APPLICATION NO.	FILING DATE	FIRST NAMED INVENTOR	ATTORNEY DOCKET NO.	CONFIRMATION NO.
10/596,726	06/22/2006	Dan Andreyevitch Yanson	35832.000130	9931
64770	7590	05/11/2010	EXAMINER	
Momkus McCluskey, LLC			BOOKER, VICKI B	
1001 Warrenville Road, Suite 500				
Lisle, IL 60532			ART UNIT	PAPER NUMBER
			2813	
			MAIL DATE	DELIVERY MODE
			05/11/2010	PAPER

Office Action Summary	Application No.	Applicant(s)	
	10/596,726	YANSON ET AL.	
	Examiner	Art Unit	
	VICKI B. BOOKER	2813

DETAILED ACTION

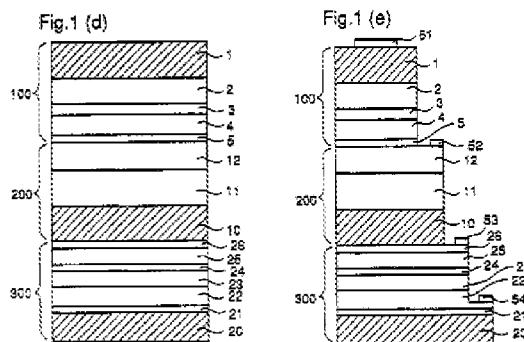
etching away (Page 4, line 13 – 14; “photolithography”; Fig. 4, Step 6; “patterning layer”) different numbers of the successive barrier layers 8, 9 in different regions F, G of the substrate 1 (FIG. 6A – FIG. 6H; Page 12, line 15 – Page 14, line 4) so as to provide different total thicknesses of barrier layer in different regions F, G of the substrate 1 (**Claim 1; Claim 37**); and

applying an intermixing agent (“annealing”; FIG. 4, Step 7; Page 13, line 27 – 31) to the surface of the substrate 1 such that the degree of intermixing in the quantum well region varies as a function of the total thickness of barrier layer, thereby forming different bandgaps in the quantum well in each of the respective regions (**Claim 1; Claim 37**; “thermally annealing 7 the heterostructure to cause intermixing in the quantum region thereby producing a semiconductor heterostructure with a surface having particular regions which exhibit different band gap shifts depending on which combination of materials they were covered by”; Page 13, line 27 – 31).

TENG ‘742 does not teach or disclose further wherein the step of etching away different numbers of the successive barrier layers is performed after deposition of the succession of intermixing barrier layers.
